SUBJECT: **RECALL CAMPAIGN - ARNAGE T, R & RL - FRONT SUSPENSION  
LOWER BALL JOINT - INCORRECT SECURING NUT FITTED - RE05/04**

FIXED OPERATIONS BULLETIN #0070

**Recall RE05/04 - Front Suspension Lower Ball Joint – Incorrect Securing Nut Fitted**

Figure 2

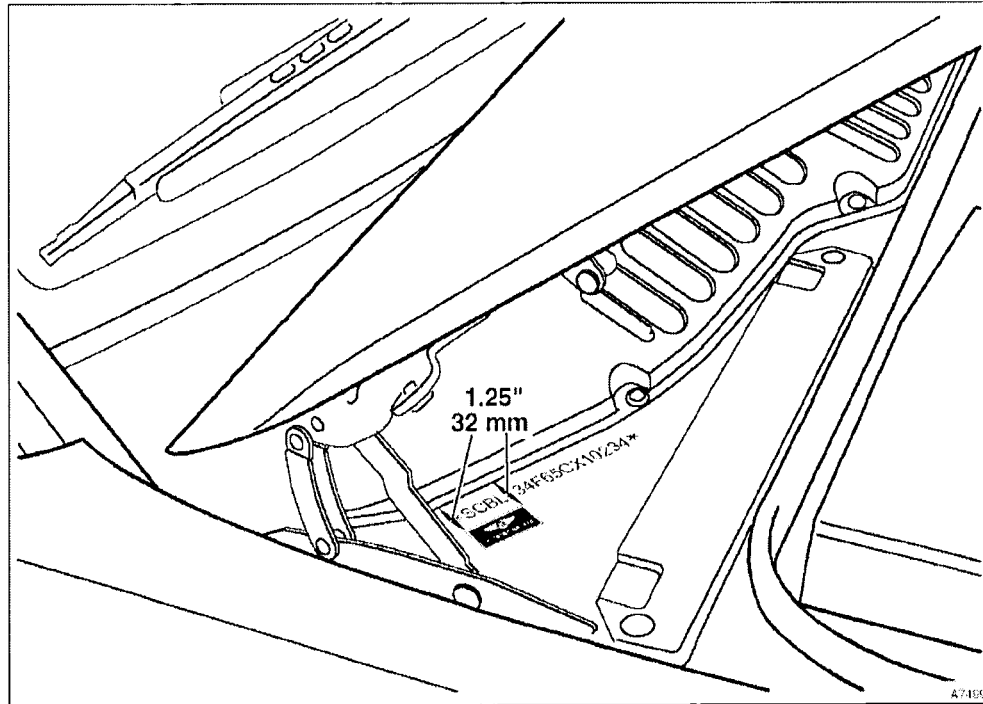
1. Drive the car onto a ramp, apply the foot operated parking brake and chock the rear wheels.
2. Remove the gearbox isolator fuse. (Refer to pin: 5936)
3. Raise ramp.
4. Remove the right hand lower ball joint retaining nut and destroy before discarding
5. Fit a new self-locking nut part no. PD25019PC and torque tighten to 140Nm (103.6lbf ft). See figure 1.
6. Repeat operations 4 & 5 for the left hand lower ball joint self-locking nut.
7. Lower ramp.
8. Refit gearbox isolator fuse.
9. Fit completion sticker. See figure 2
